**Tyres: UN Regulation No. 109 (Retreaded tyres for commercial vehicles and their trailers)**

**Proposal for amendments to UN Regulation No. 109**

**Submitted by the experts from the Bureau International Permanent des Associations de Vendeurs et Rechapeurs de Pneumatiques (BIPAVÉR)\***

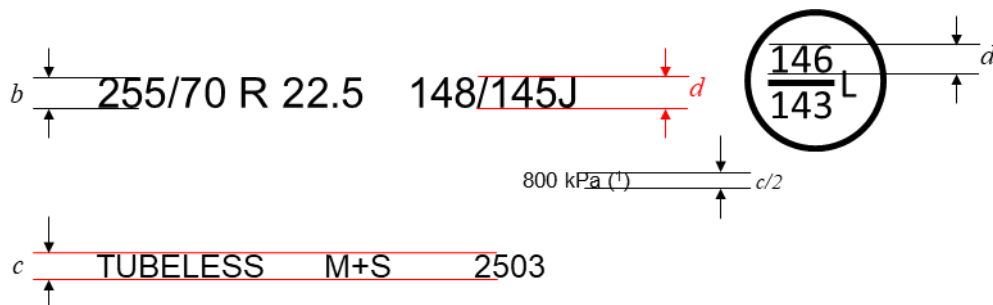
- 12.3. Until 1 September 2024, Contracting Parties applying this Regulation may continue to grant type approvals according to the 02 series of amendments to this Regulation, based on snow performance test described in Annex 7 to this Regulation using SRTT14 as reference tyre. <sup>(a)</sup>**

**"Example 1:**

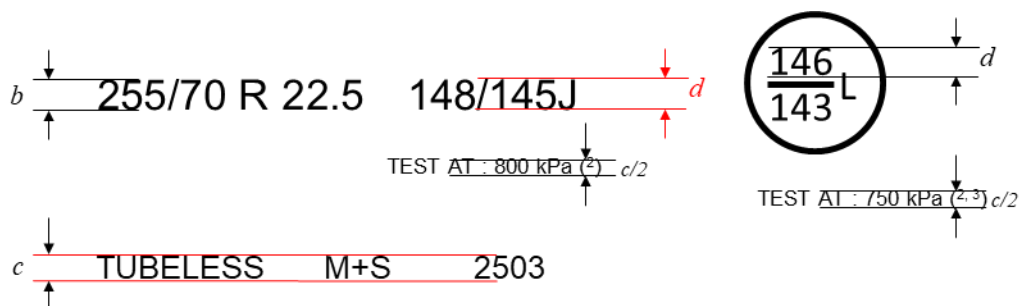
Figure, replace and amend to read:

- (1) PSI marking instead of kPa is allowed for tyres first type approved before 1 January 2018. The kPa marking may be preceded by "TEST AT : " or, alternatively, by "TEST INFL : " or the symbol "@".

Requiring to be inflated to ~~620~~**800** kPa for **both** load/speed endurance tests **in Example 1 and 800 kPa for the load/speed endurance test according to the main load/speed combination and 750 kPa for the test according to the additional load/speed combination in Example 2** for which the PSI symbol is 90."
